# UNIVERSITY OF KENTUCKY Purchasing Division

CCK-2632-22

ADDENDUM# 2

**UK Reynolds Building #1 College of Design  
BID PACKAGE - 01  
ADDENDUM No. 2  
CCK-2632-22  
05/25/2022**

Sheet Title:  
**Lower Level - Plumbing Demolition - West**

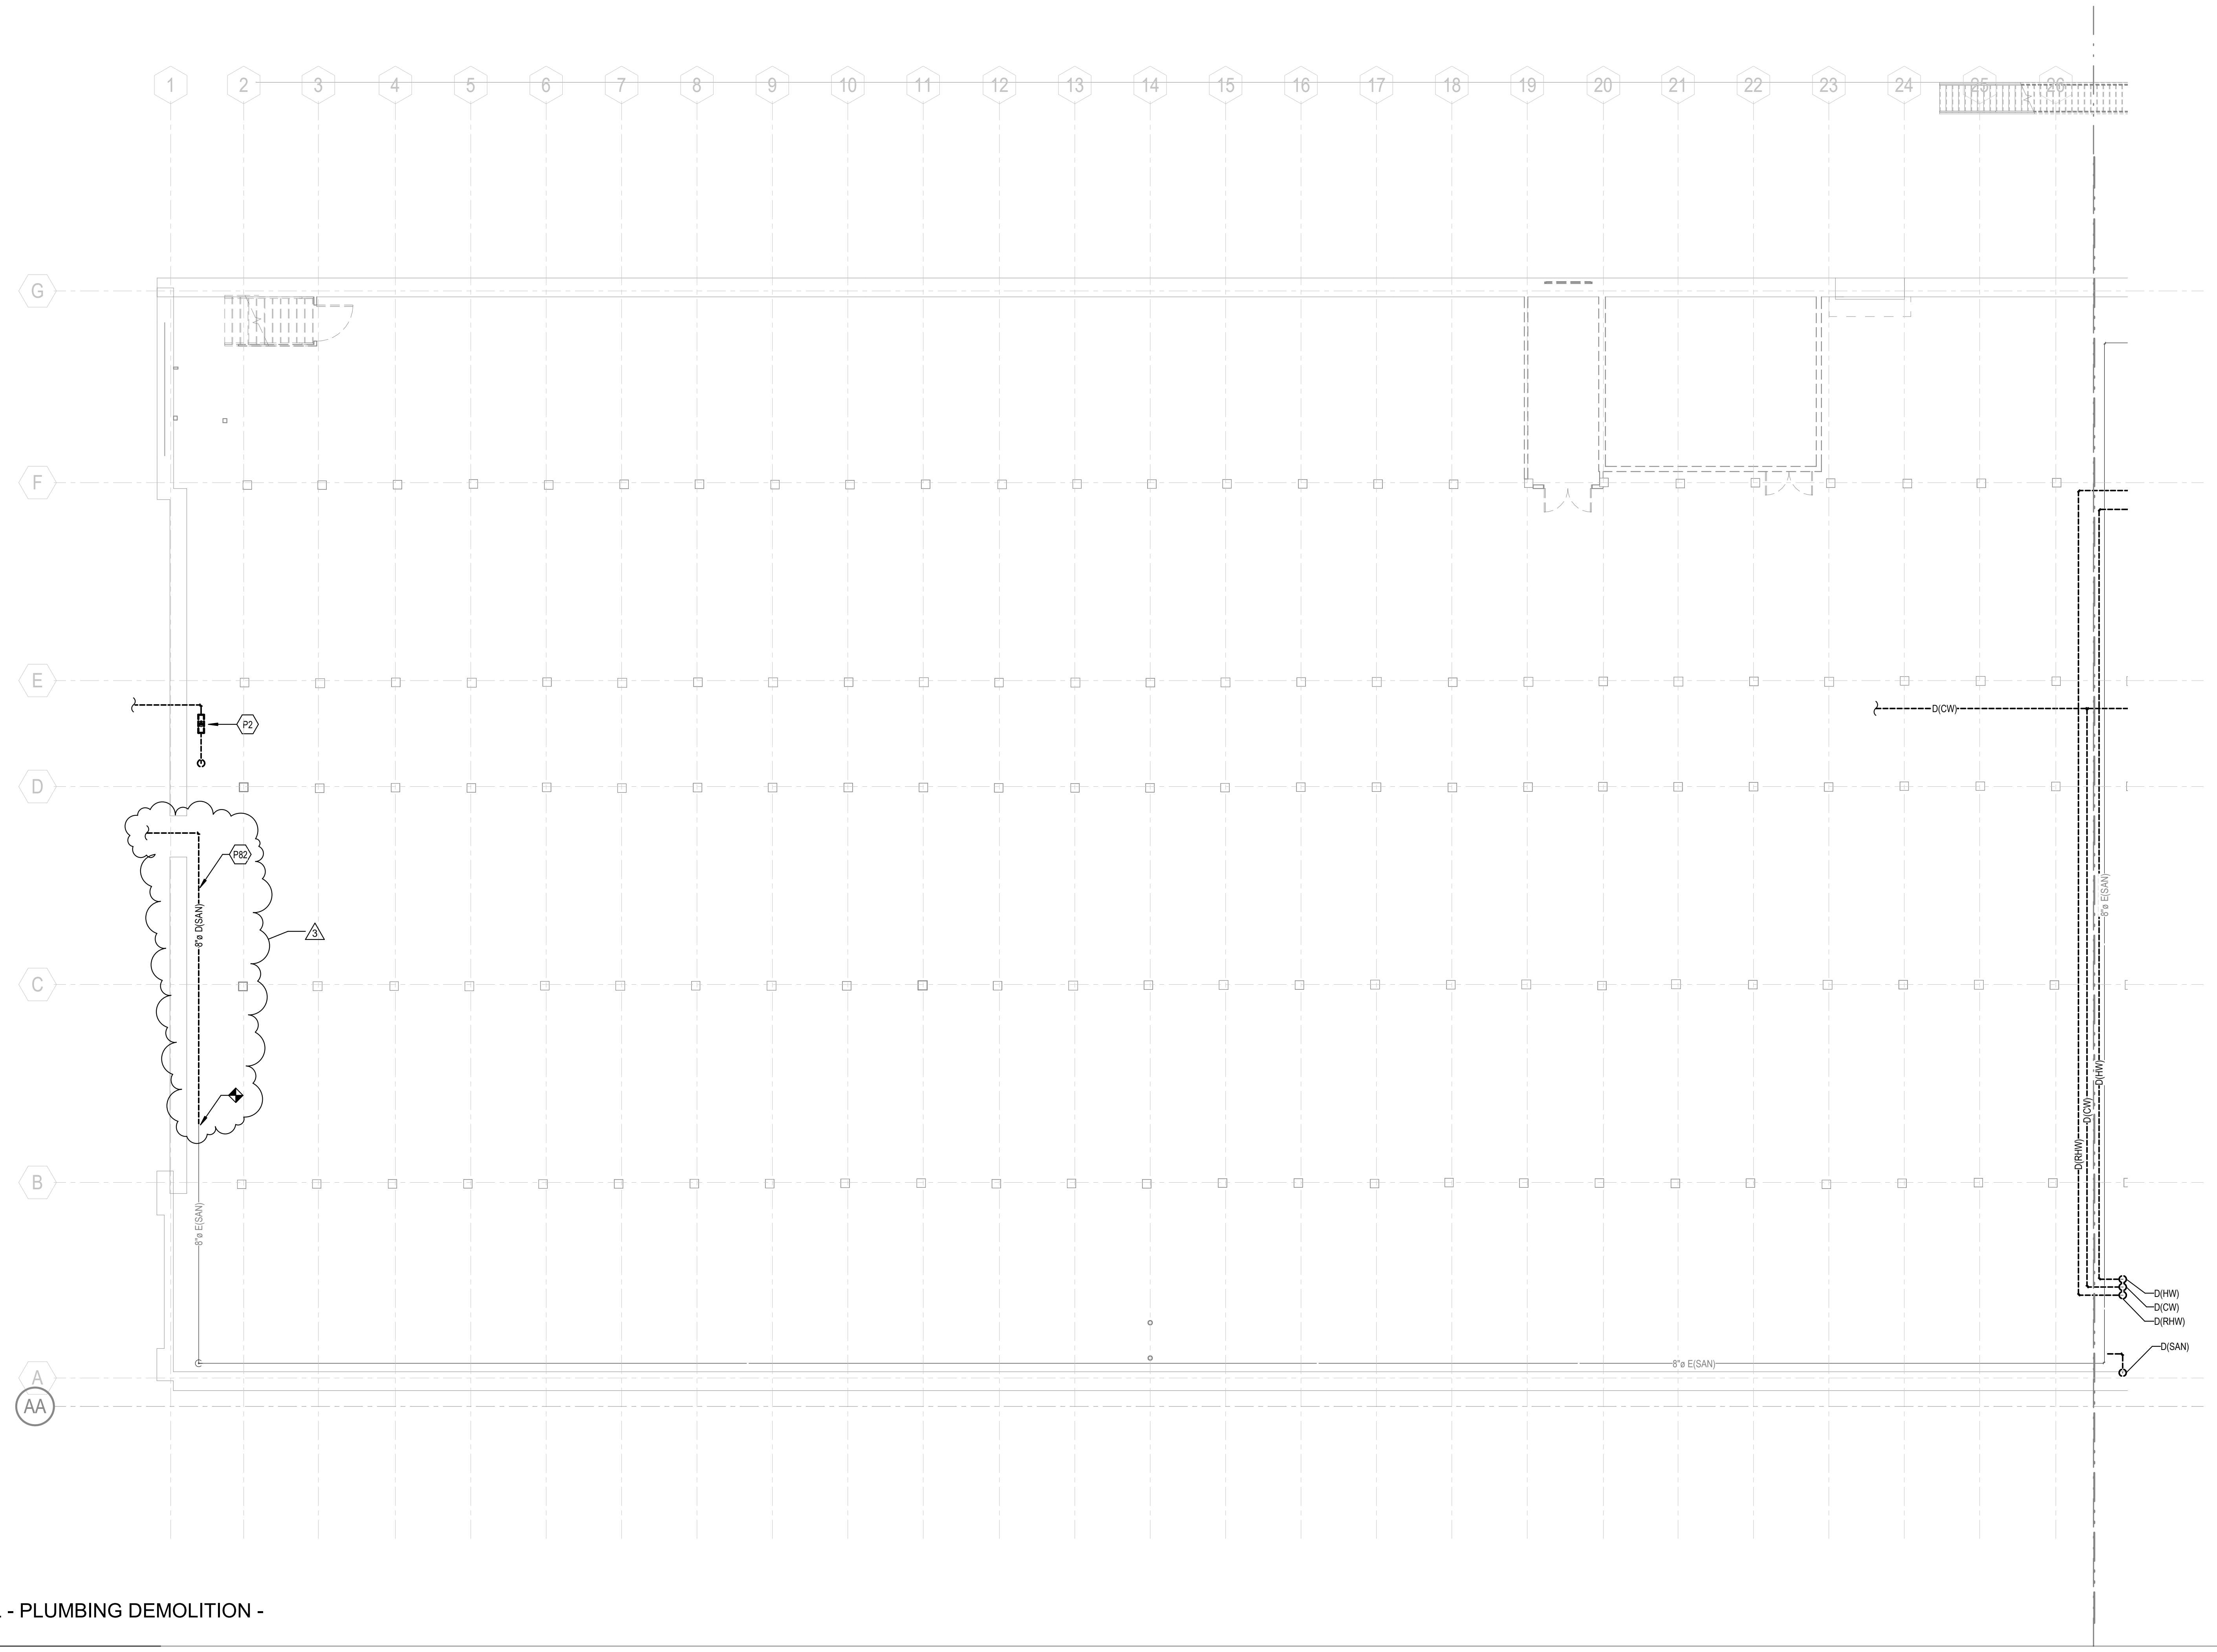
- Item #11 Refer to Plumbing Drawings, Sheet P-100A  
 A. Existing 8" sanitary main exiting the building is to be demoed back out of the new staircase. Tag note P82 was added.

**P-201A**

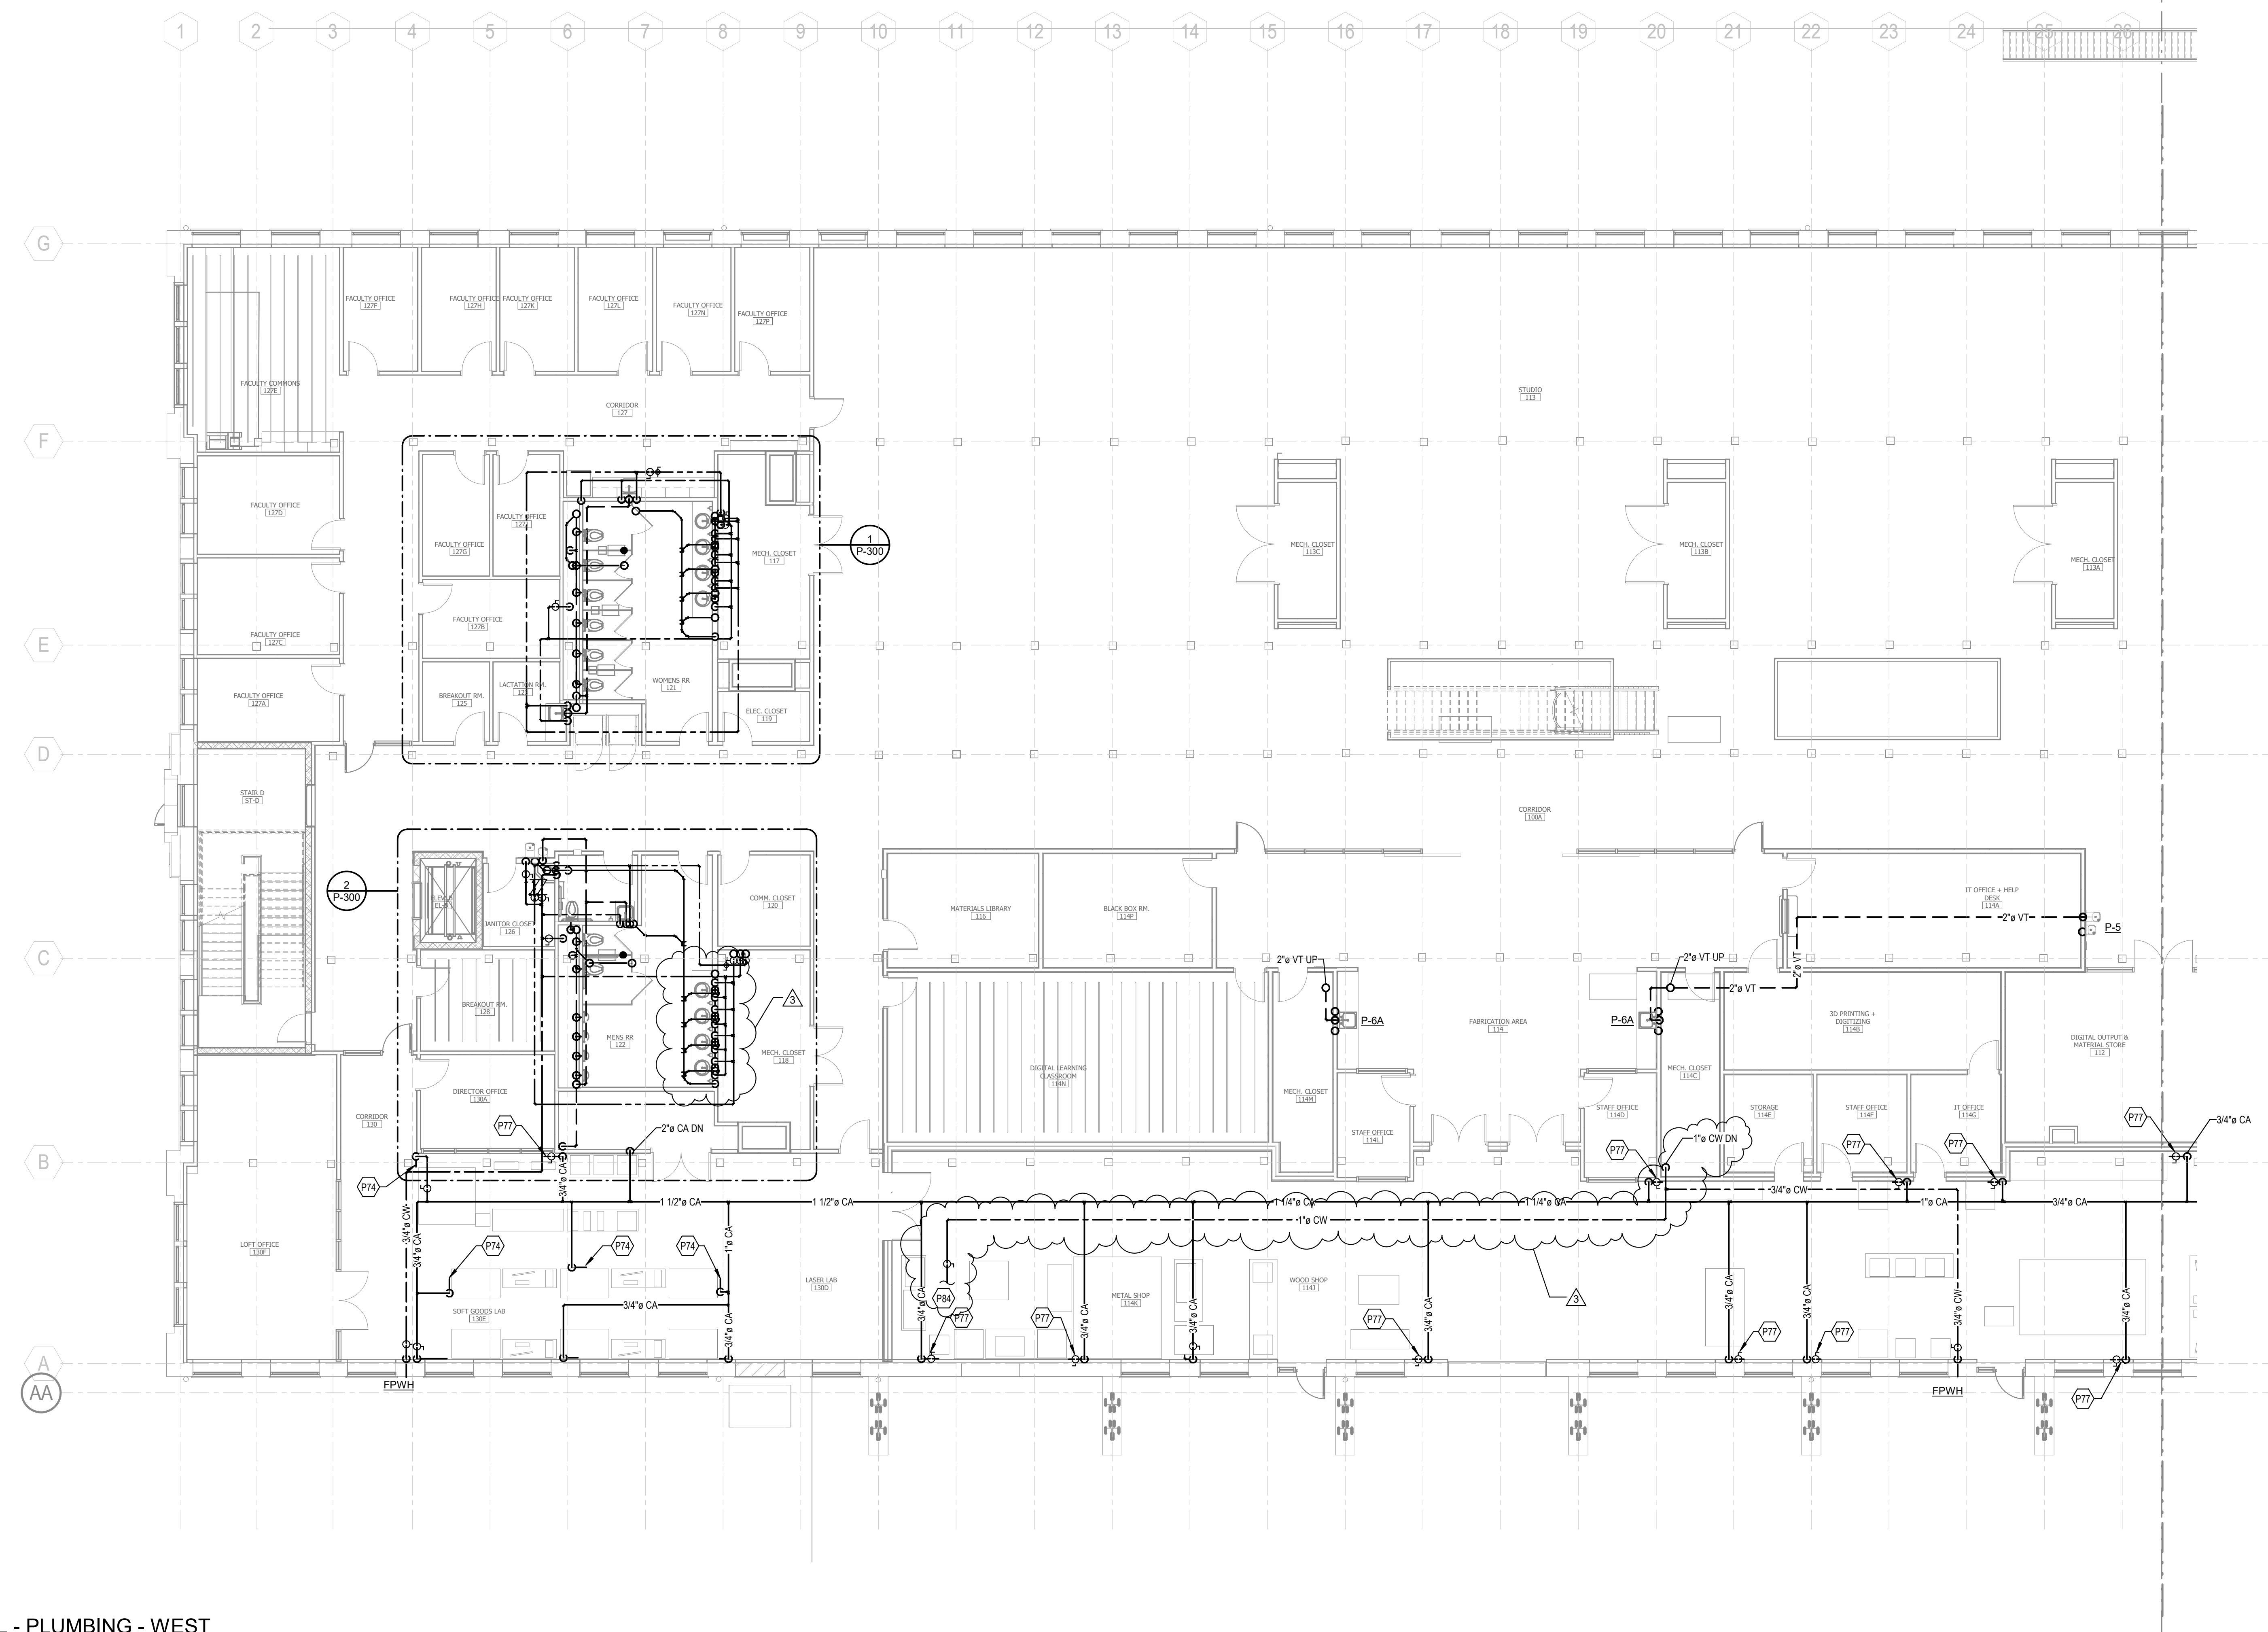
B. Increased domestic cold water pipe to 1" for spark extinguisher system.
- Item #13 Refer to Plumbing Drawings, Sheet P-201A

9 DUST COLLECTION SYSTEM SCHEMATIC  
SCALE: NONE

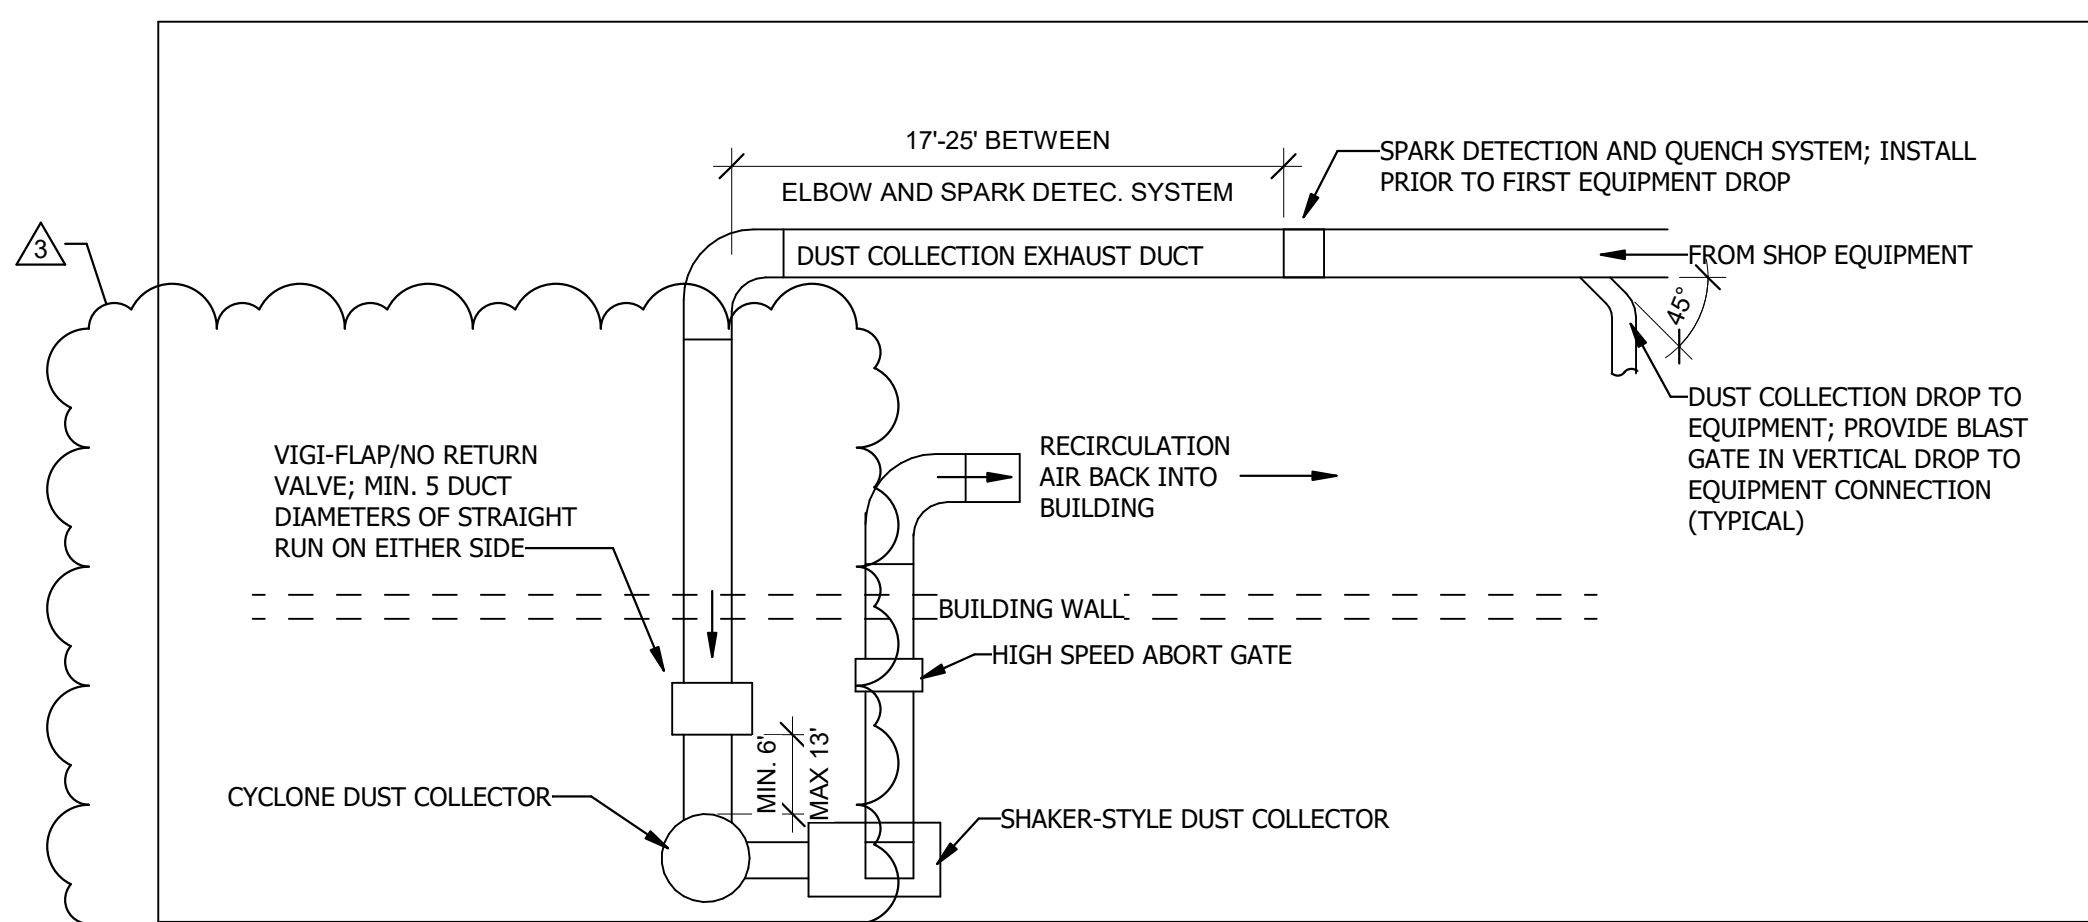
- Item #8 Refer to the Mechanical Drawings, Sheet M-601  
 A. Refer to updated Dust Collection System Schematic.
- Item #9 Refer to the Mechanical Drawings, sheet M-801
